CITY OF ALBUQUERQUE

December 13, 2018

RE: Murphy Express – 1358 Wyoming Blvd
Revised Grading Plan
Engineer's Stamp Date: 12/04/18
Drainage Report
Engineer's Stamp Date: 01/27/18
Hydrology File: J20D037

GRADING PLAN

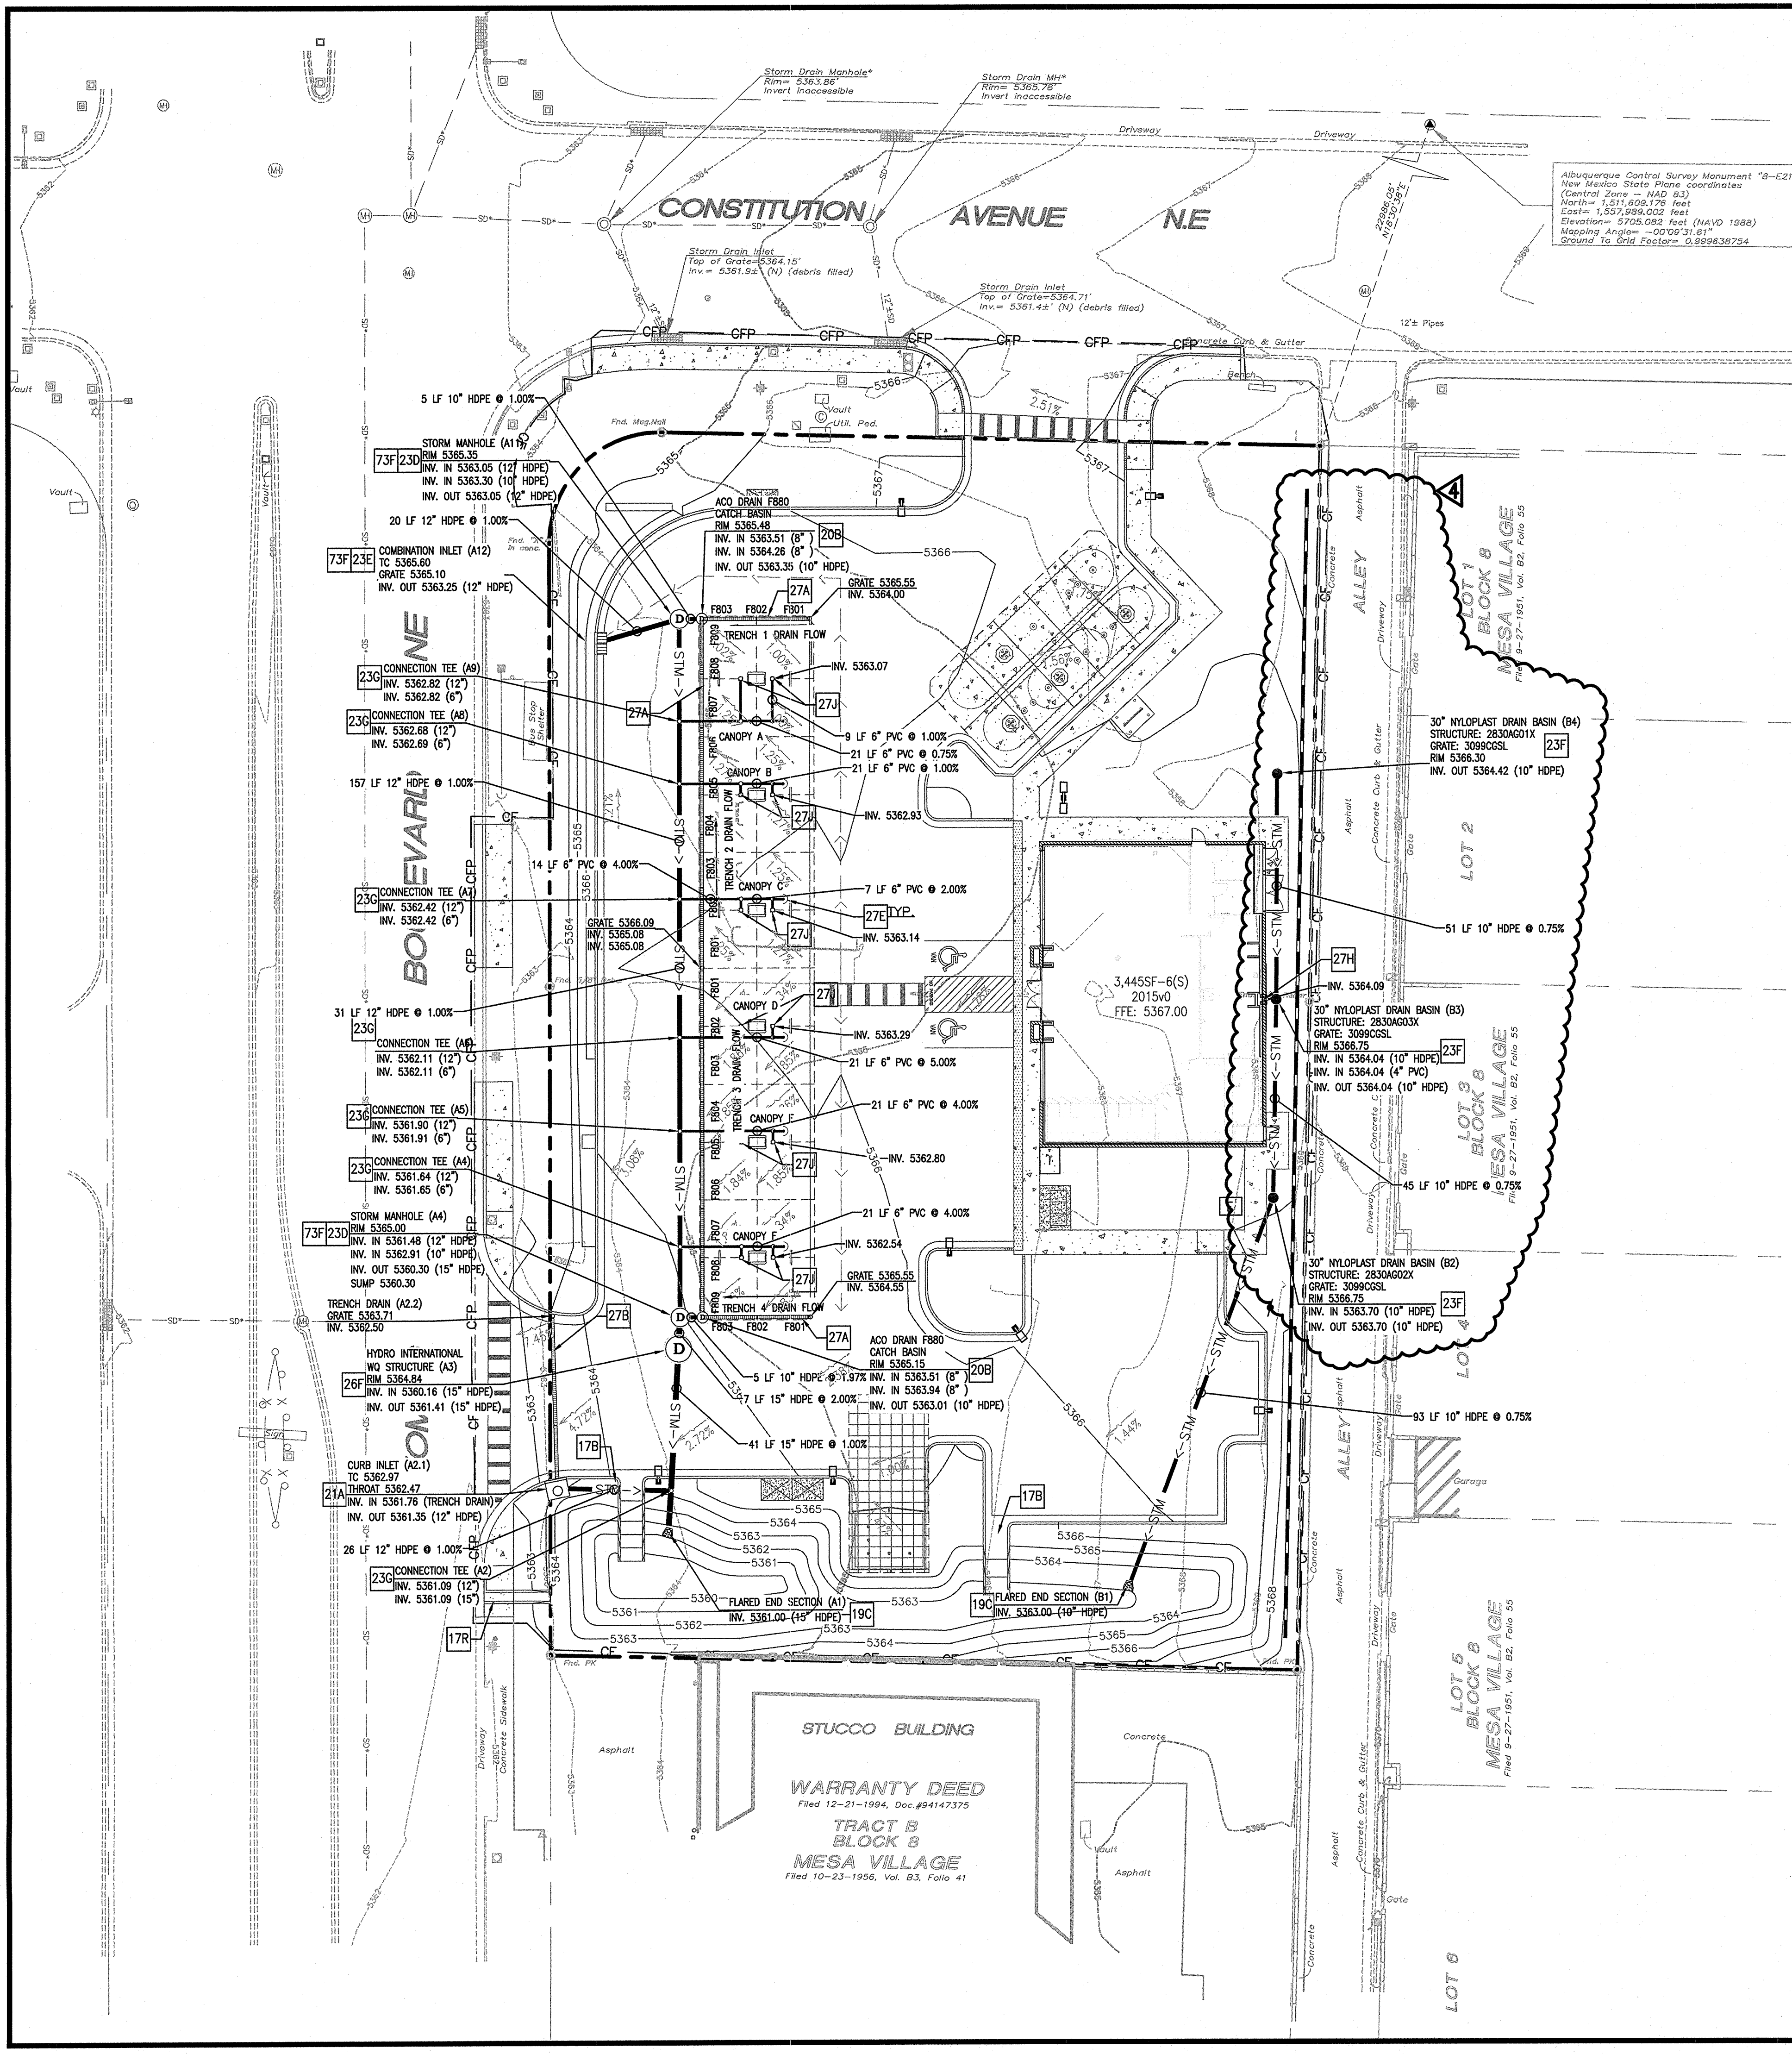
Based upon the information provided in your submittal received 12/04/2018, the Revised Grading Plan is approved for Building Permit and SO-19 Permit. For the SO-19 Permit, please follow the attached SO-19 Notes.

Please attach a copy of this approved plan in the construction sets for Building Permit processing along with a copy of this letter. Prior to approval in support of Permanent Release of Occupancy by Hydrology, Engineer Certification per the DPM checklist will be required.

Please provide Drainage Covenant per Chapter 17 of the DPM prior to Permanent Release of Occupancy for the stormwater quality pond. Please submit these to the 4th floor of Plaza de Sol. A \$25 fee for each will be required. The Drainage Covenant can be obtained at our webpage.
<https://www.cabq.gov/planning/development-review-services/hydrology-section>
